SUBJECT: APPROVAL TO AWARD CONTRACT FOR THE LAS PALMAS AVENUE WIDENING PROJECT TO TEICHERT CONSTRUCTION

ADDENDUM NO. 1

TO PLANS AND SPECIFICATIONS FOR
LAS PALMAS AVENUE WIDENING

EXHIBIT A
LAS PALMAS AVENUE WIDENING
 SHEET C2, SECTION B-B, OF TRASH RACK DETAIL

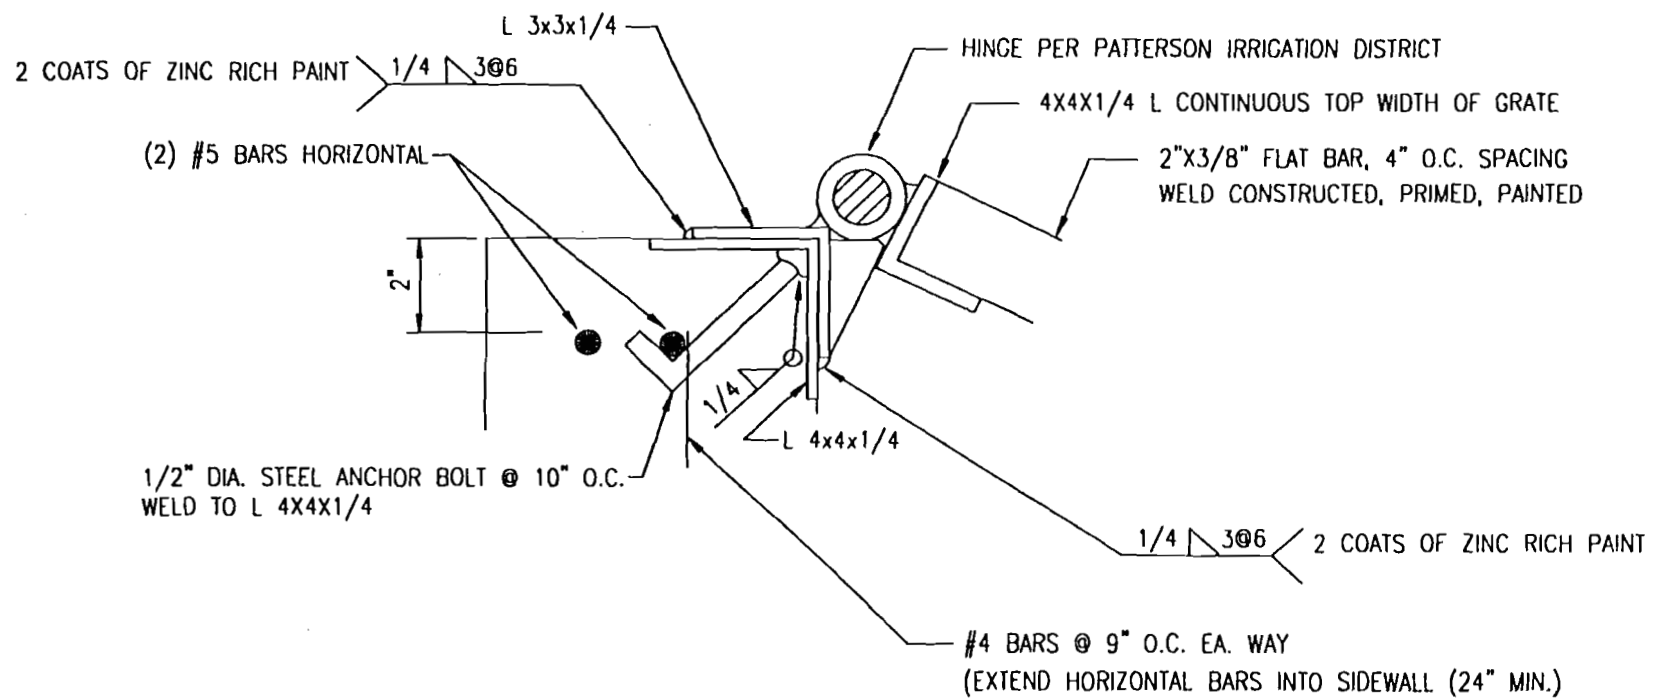
1. Drawing C2, sheet 15 of 15, is missing section B-B of the trash rack detail. Add Exhibit A to drawing C2 for the missing section.

NOTE:
 ANCHOR BOLTS & 4X4X1/4 ANGLE TO BE POURED
 IN PLACE. TOP OF ANGLE TO BE FLUSH WITH TOP
 OF CONCRETE.

SHEET C2, SECTION B-B, OF TRASH RACK DETAIL

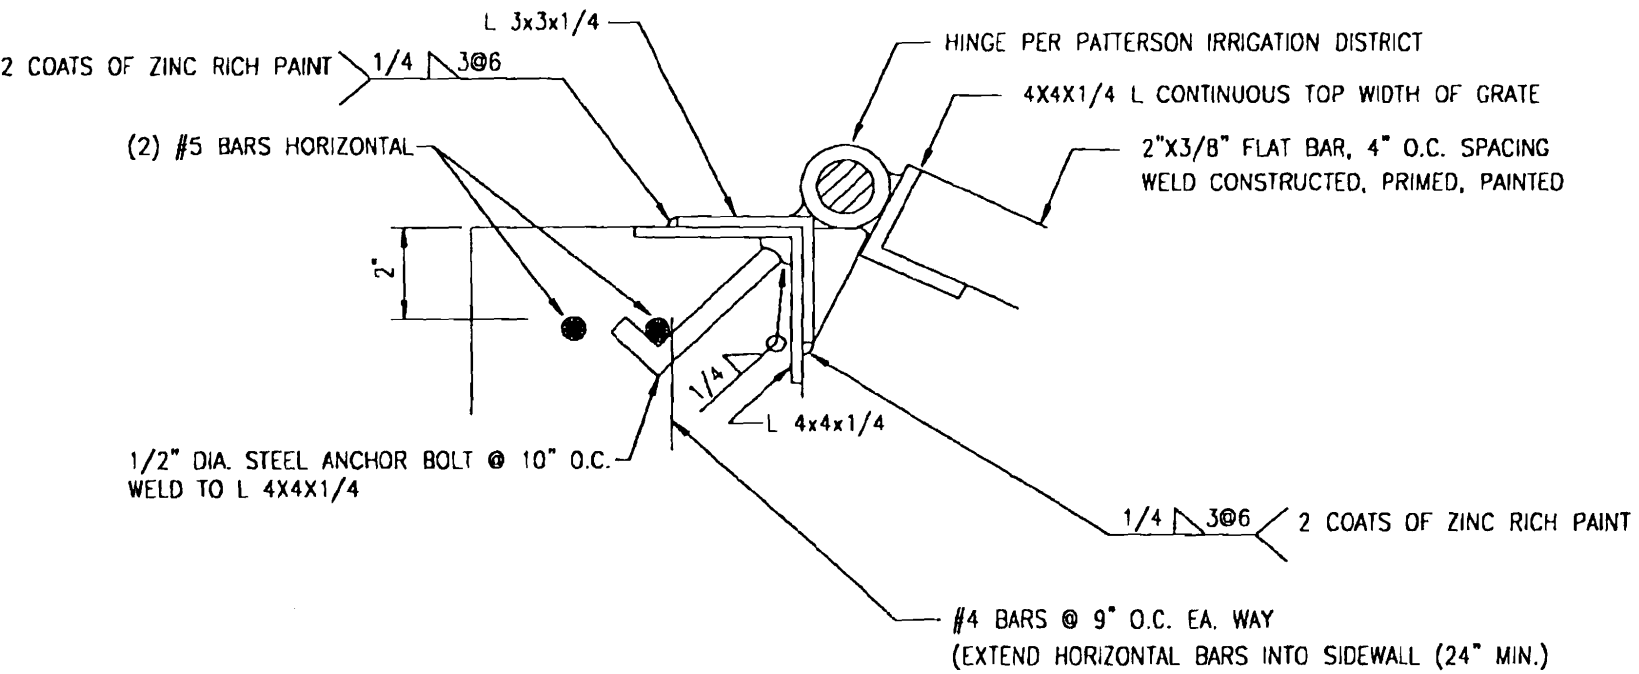
1. Drawing C2, sheet 15 of 15, is missing section B-B of the trash rack detail. Add Exhibit A to drawing C2 for the missing section.

NOTE:
ANCHOR BOLTS & 4X4X1/4 ANGLE TO BE POURED
IN PLACE. TOP OF ANGLE TO BE FLUSH WITH TOP
OF CONCRETE.
